# Proposed text based on TCI

G. ZIMMERMAN, CME CONSULTING

5/17/2023

## TCI/MDI specification

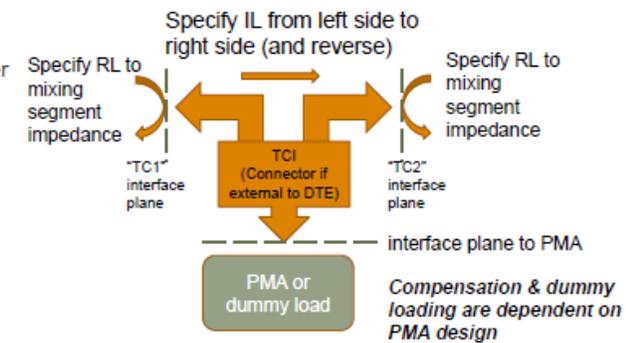
TCI connects to left and right trunk pairs and presents both sides as a 4 pin interface to the PMA (MDI plane)

The TCI meets different RL & IL specs depending on whether PMA/loading is or is not attached

When no PMA attached, the TCI maintains continuity between the left and right sides of the mixing segment as part of mixing segment (like an inliner)

When a PMA is attached, the TCI routes continuity of through 4 signal interface (p\_left, n\_left, p\_right, r\_right) to the PMA, PMA completes the path from left to right

Normal RL specs associated with the MDI are met at both the left and right side of the TCI – not at a single MDI interface plane

TCI specification contains the left to right side insertion loss when the PMA is attached

Updated to remove "MDI" language and clarify it is the PMA attached
